**Yiribana Logistics Estate (SSD-10272349) –
Environmental Impact Statement (EIS)**

Detailed advice to DPIE Planning & Assessment regarding the Yiribana Logistics Estate (SSD-10272349) – Environmental Impact Statement

Figure 3 - Watercourse riparian zones (Drawing no. C013874.06-SSDA420 - from Appendix K – Civil Drawings)

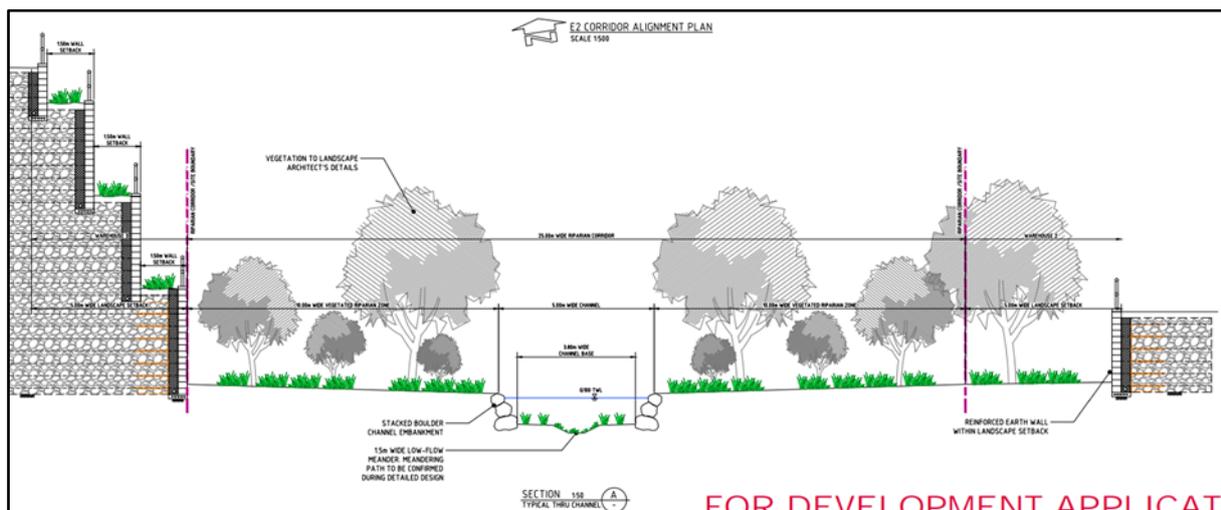
either side, and an outer Vegetated Landscape Zone of approximately 5m width on either side.’ The EIS Watercourse Riparian Zones Figure (Figure 3 below), refers to the outer 5m Vegetated Landscape Zone as the Landscape Set-back, and this has not been included in the riparian calculations according to the Figure 3. Therefore, it is unclear whether the Vegetated Landscape Zones are part of the riparian corridor or not. Furthermore, from the plans provided in Appendix K (Civil Plans) the Vegetated Landscape Zones are only present in some sections along the watercourse or on one side (as shown in Figure 3 below).

NRAR believes that the proponent actually proposes a total riparian area of 20m which is composed of two 10m wide inner Vegetated Riparian Zones either side of the waterway. Should the Landscape Zones be included in the calculations, it is still less than the 40m recommended corridor width for 2nd order streams. We recommend that a 40 metre riparian corridor be required consistent with the Guidelines for Controlled Activities on Waterfront Land (NRAR 2018).

2.1 The proponent should maintain a 40 metre riparian corridor in accordance with the *Guidelines for Controlled Activities on Waterfront Land (NRAR 2018)*.

Figure 1 – From Drawing C013874.06-SSDA420 (E2 Corridor General Arrangement Plan) from Appendix K – Civil Drawings

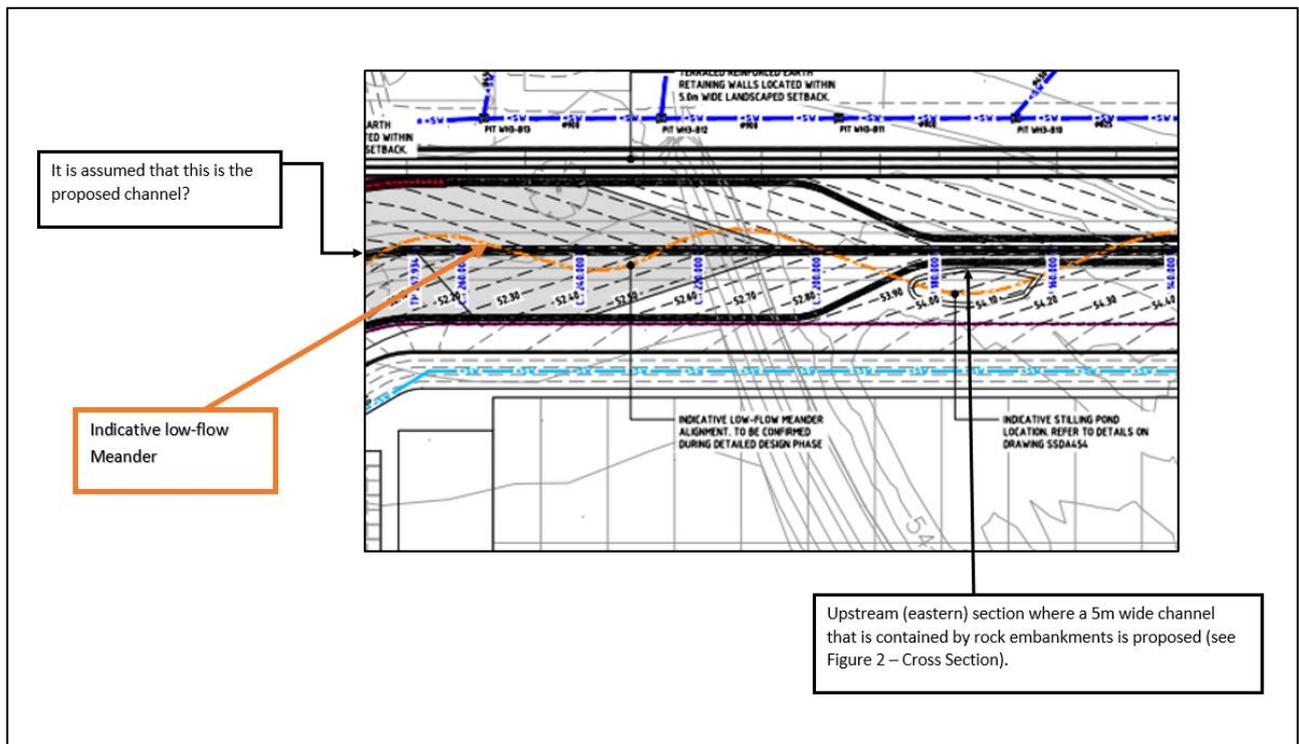
NRAR notes that the low-flow meander appears to be currently mapped (significantly) outside of the proposed 5-metre channel width on the upstream (eastern) side.

The proponent should provide further details on the low-flow path (as shown in Figure 1 below) regarding the associated channel containment infrastructure. NRAR notes that the channel design appears to change over the course of the site (as seen in Figure 1) from east to west (right to left), and that Figure 2 (below) indicates that this flow path will be contained on the upstream side within a 5-meter-wide channel (contained by rock embankments). NRAR acknowledges the low-flow meander alignment is indicative (and to be confirmed during the detailed design phase), but has concerns regarding the significant distance difference between the low-flow path meanders and the proposed channel path, especially in the eastern/upstream section where the channel is confined to 5 metres wide. NRAR also suggests that Drawing C013874.06-SSDA420 (E2 Corridor General Arrangement Plan from Appendix K – Civil Drawings) should clearly indicate where the location of the cross-sections are mapped.

2.3 That the proponent clarify where the water will flow at times of low flow in relation to the proposed channel infrastructure.
